RB2-13

R102.7.1

Proposed Change as Submitted

Proponent: David Bonowitz, Chair, Existing Buildings Subcommittee, Code Advisory Committee, representing National Council of Structural Engineers Associations (dbonowitz@att.net)

FIGURE 403.1(1) DISCONTINUOUS FOOTERS

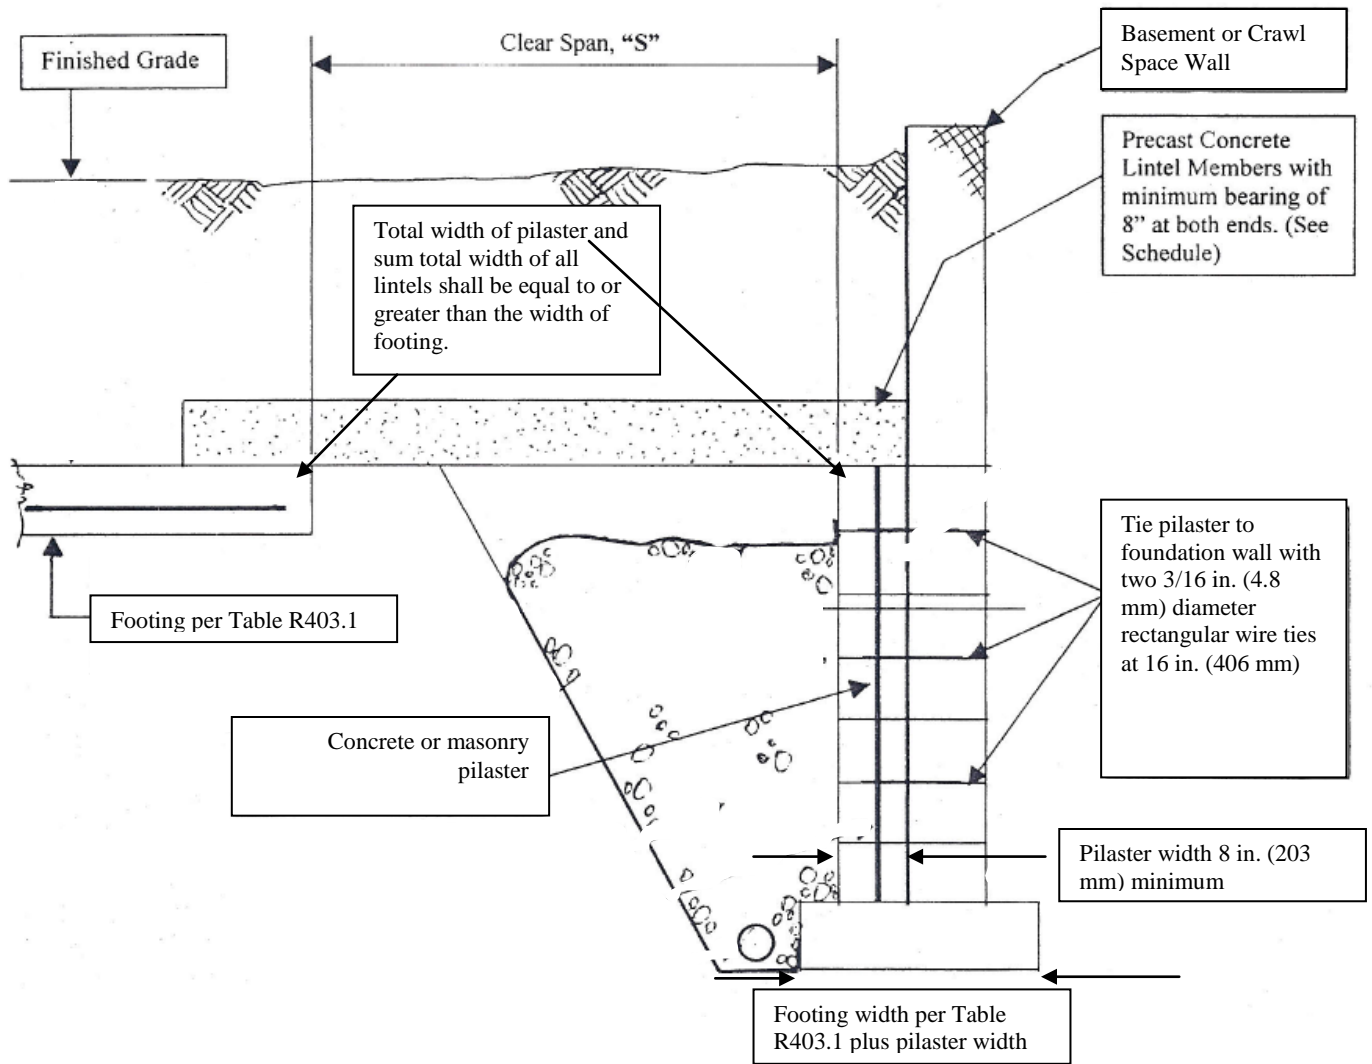
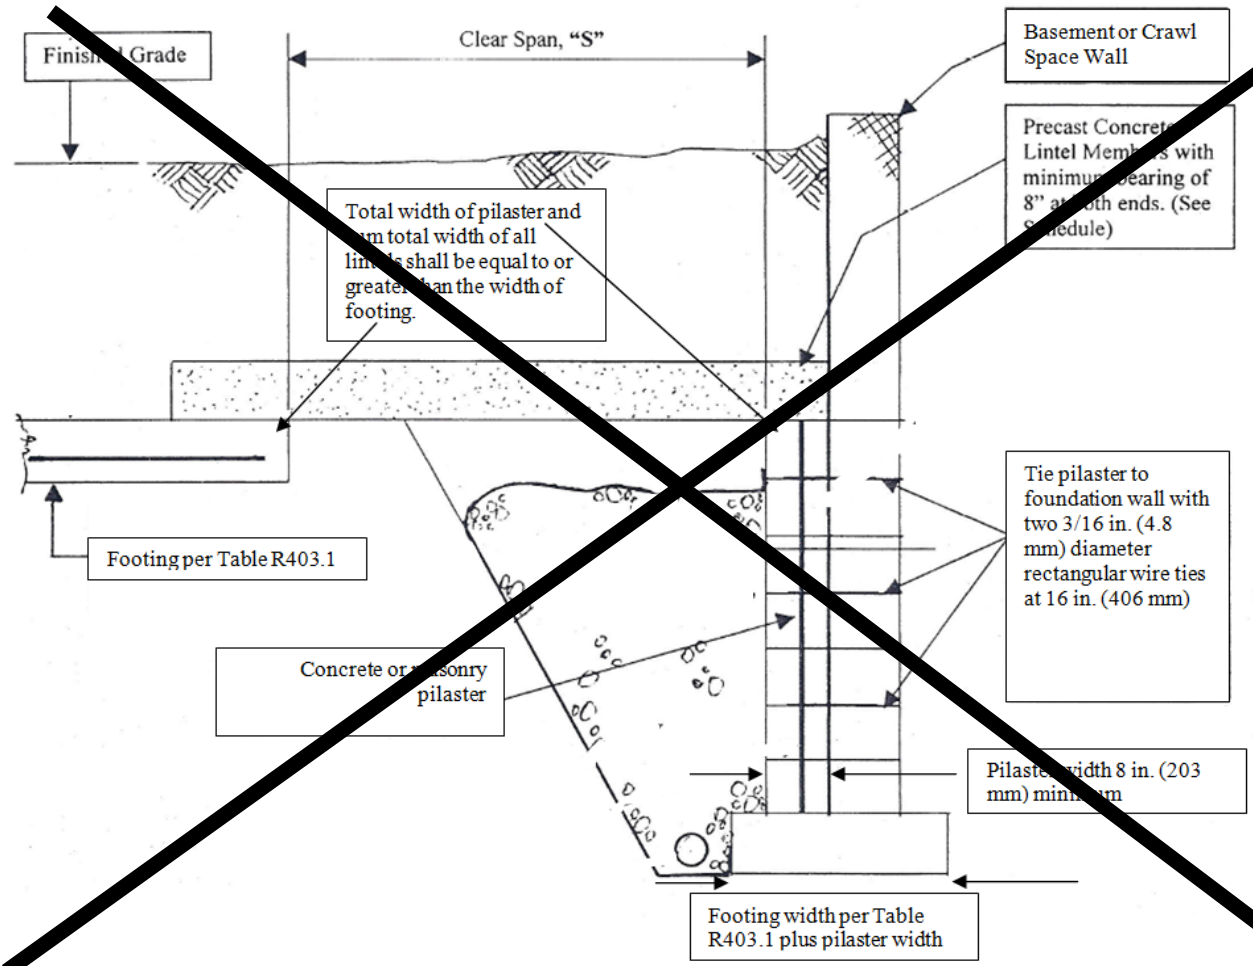
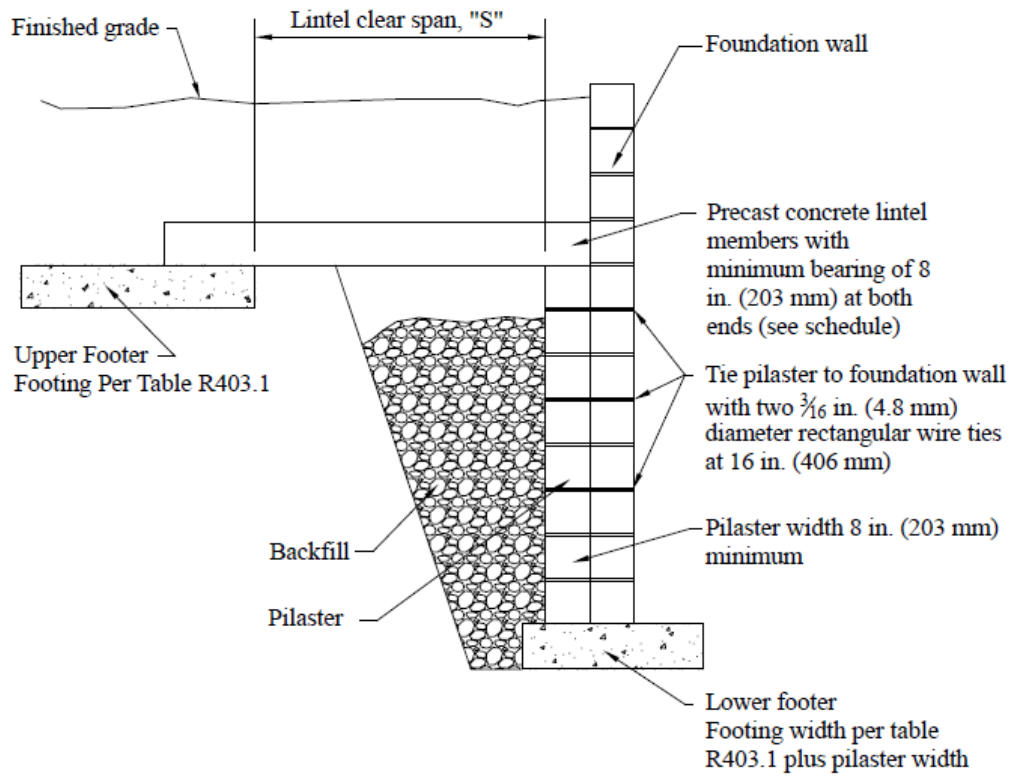
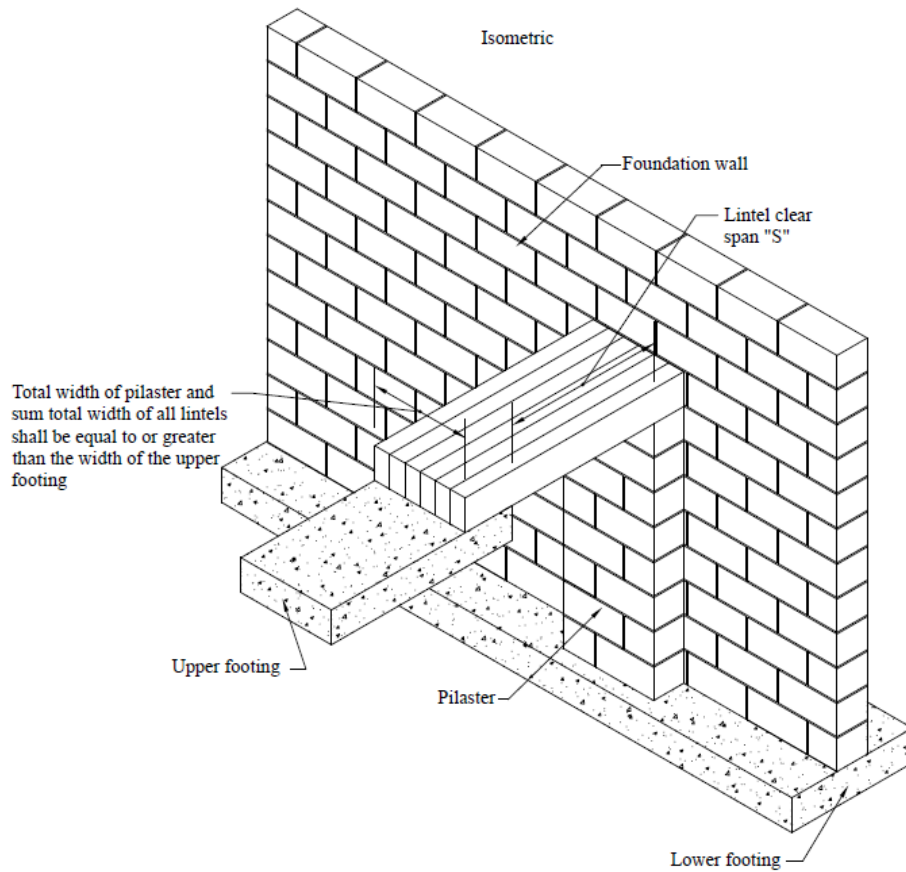
At transitions between footings located at different elevations, precast concrete lintels complying with Figure R403.1(1) shall be permitted in Seismic Design Categories A, B, and C.

Modify the proposal as follows (delete proposed Figure 403.1(1) and replacing with new Figure 403.1(1))

PROPER PLACEMENT OF BOLTS WITH CODE CHANGE

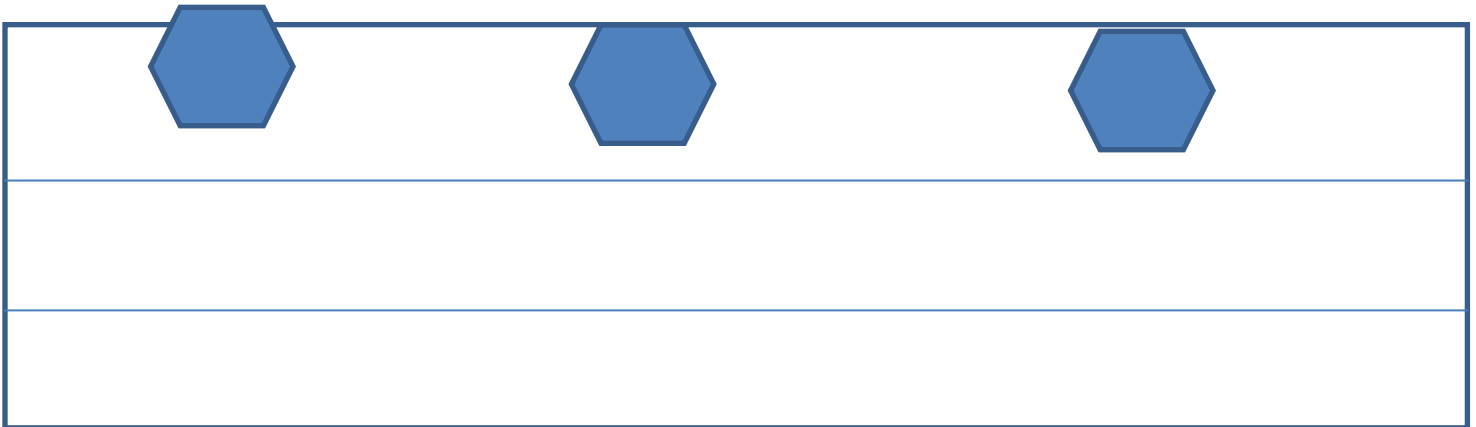
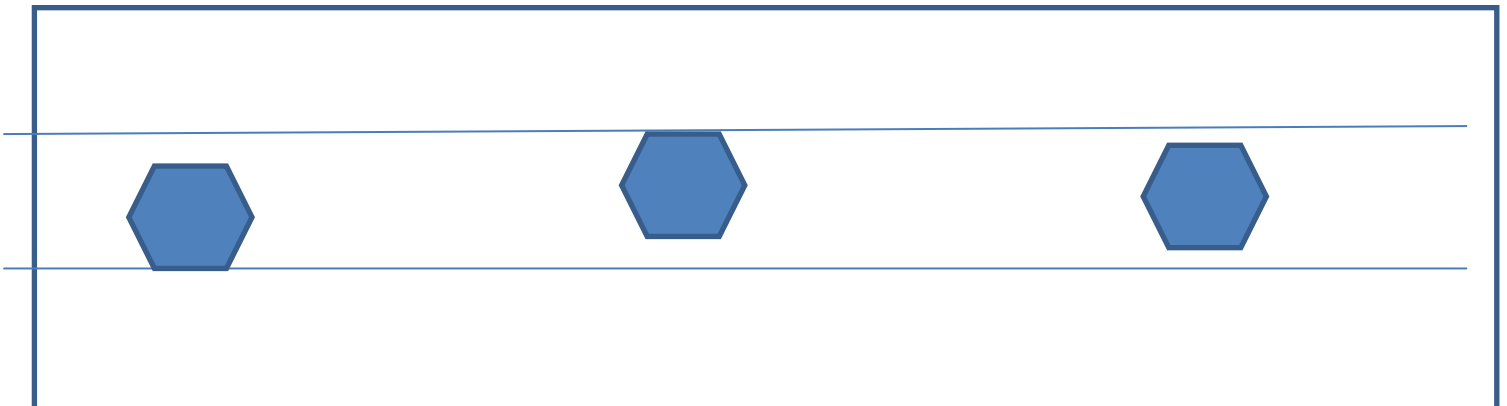
Reason: It has become a common occurrence to see an anchor bolt placed at the edge of the sole plate, and on many occasions the threads of the bolt are visible. The "practicing industry standard" is for the bolt to be located at least two bolt diameters from the plate's edge, but there is nothing in the IRC to govern this. We require two bolts per plate, within 12" of a break, and spaced no more than 6 feet apart, but nothing plainly referencing its placement from the plates edge. Having a specified placement of the bolt in the bottom plate allows for proper enforcement while still giving some flexibility to the contractors. Simpson Strong Tie has performed tests demonstrating that the bolt lost the expected anchoring capacity when placed closer than 1 3/4" from the plate's edge.

Both the Simpson Strong Tie Wood Construction Connectors 2011-2012 edition and the USP Structural Connectors state that their connectors must have a minimum placement of 1 3/4 inches from the edge. The IRC reference the NDS for wood design for items not covered in the code like wood edge and end distances. The 2012 NDS has edge distance of 3/4" for shear and 2" for wind loads (Table 11.5.1C). So if the edge distance is 1-1/8" you would need to reduce the anchor capacity with an 0.56 allowable load adjustment factor (1.125/2) when resisting wind loads. So you can space in the middle 1/3 of plate, but you may need to increase the number of bolts for wind.

COMMON PLACEMENT OF BOLTS IN THE FIELD

Figure 4. Load-Displacement Curves for Deck With and Without Hold-downs

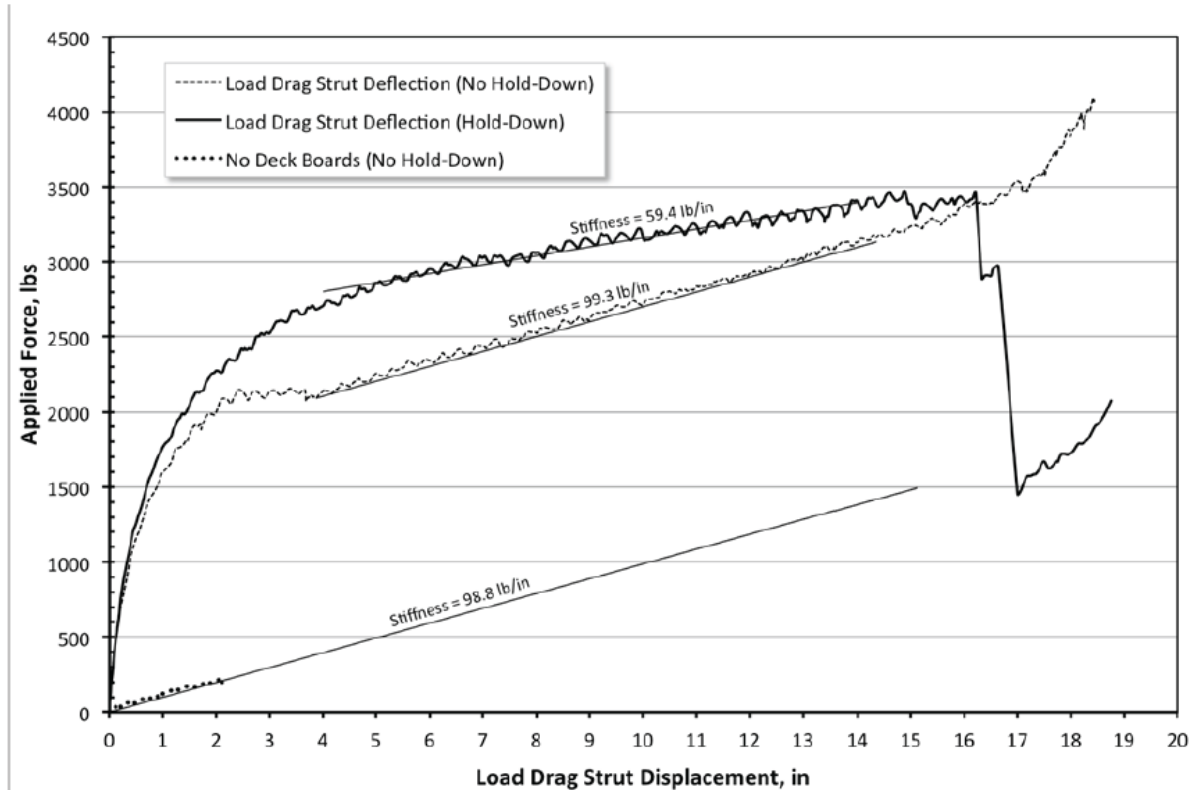
According to the graph below from the research, the deck experienced a horizontal deflection at approximately 17 inches at a load just shy of 3500 lbs. However, when loading continued upwards of 7,000 lbs, "the lag screws did not show any visible signs of withdrawal". I think the answer is that lag screws do withstand lateral loads, and band joists don't get pulled from homes.

**FIGURE R507.10.1
FREE-STANDING DECK DIAGONAL BRACING**

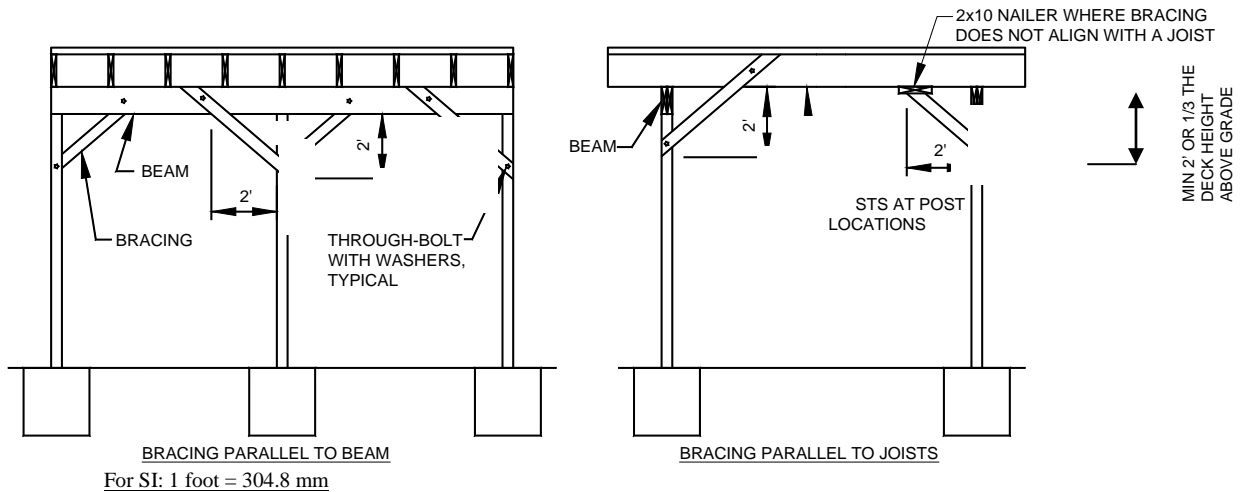
R507.10.1 Diagonal bracing. Diagonal bracing shall be installed on free-standing decks greater than 30 inches (762 mm) above grade in accordance with Figure R507.10.1. Bracing shall be placed at a 45 degree angle at each post location in the parallel and perpendicular directions to the beam. Bracing shall be a minimum of nominal 2x4 lumber and shall be fastened to framing with one 1/2 inch (9 mm) diameter through bolt with washers at each end. The diagonal brace shall be a minimum of 2 feet long measured as shown in Figure R507.10.1 or at least 1/3 the height of the deck above grade.
